# SERVICE INSTRUCTION

Service Instruction No. 1453B  
(Supersedes Service Instruction No. 1453A)  
Engineering Aspects are  
FAA (DER) Approved

SUBJECT: Procedure to Replace Oil Filter Converter Plate Gasket

MODELS AFFECTED: All Lycoming dual magneto engines and TIO-541-E and TIGO-541 series engines.

Figure 1. Dual Magneto and Oil Filter Converter Plate

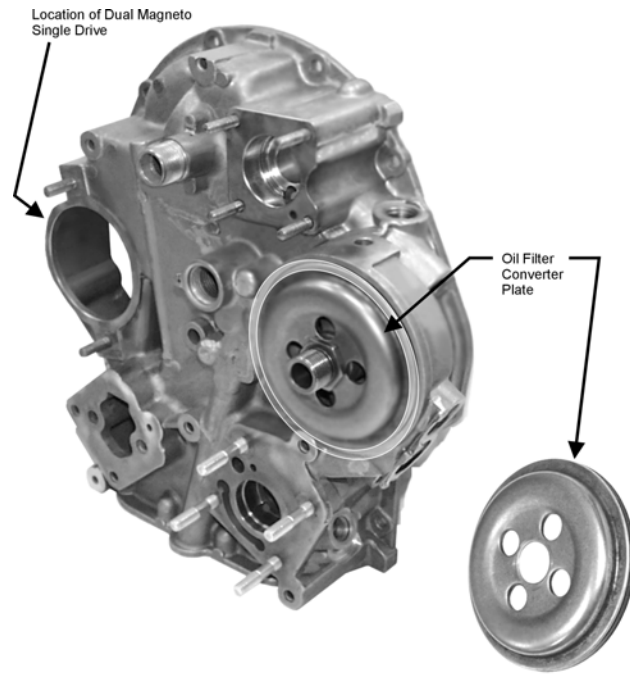
This Service Instruction is to be followed to replace either just the gasket P/N LW-13388 with a new gasket P/N 06B23072 or to install an oil filter converter plate kit P/N 54E23093 (supersedes Kit P/N 54E23073 which is no longer available). The kit P/N 54E23093 contains a new oil filter converter plate P/N 54E23092 which includes the new converter plate gasket P/N 06B23072.

This gasket replacement is a necessary precaution because some gaskets, P/N LW-13388, have been made of incorrect material. As a result of the defective material, the gasket can become pressed out from its seat and cause oil leakage between the converter plate and accessory housing.

1. Disable all power to the engine.
2. Remove the oil filter and converter plate. Refer to Figure 1.

3. Have the oil filter analyzed for metal contaminants, if necessary.
4. Remove and discard the gasket (if the old gasket, P/N LW-13388).
5. Remove all traces of the old gasket.
6. If replacing only the gasket:
  - a. Thoroughly clean the converter plate and gasket surface on the converter plate with methyl ethyl ketone (MEK) or equivalent solvent.
  - b. Install and bond a new gasket P/N 06B23072 to the converter plate using 3M Scotch Grip Industrial Adhesive No. 847. Apply adhesive in accordance with the manufacturer's instructions.
  - c. After the gasket is installed and bonded, vibropeen the number 543 along the outer surface of the converter plate flange as shown in Figure 2.

Figure 2. 543 Vibropeen Marking

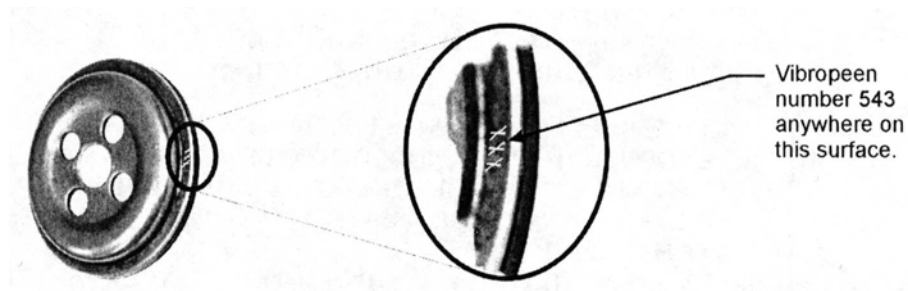
The converter plate in each kit is identified with the part number 54E23092 permanently marked on the plate in the same location as shown in Figure 2.

Steps 6a, b, and c need to be done every time the new gasket P/N 06B23072 is installed and a check of the logbook entry to show compliance with Service Bulletin No. 543.
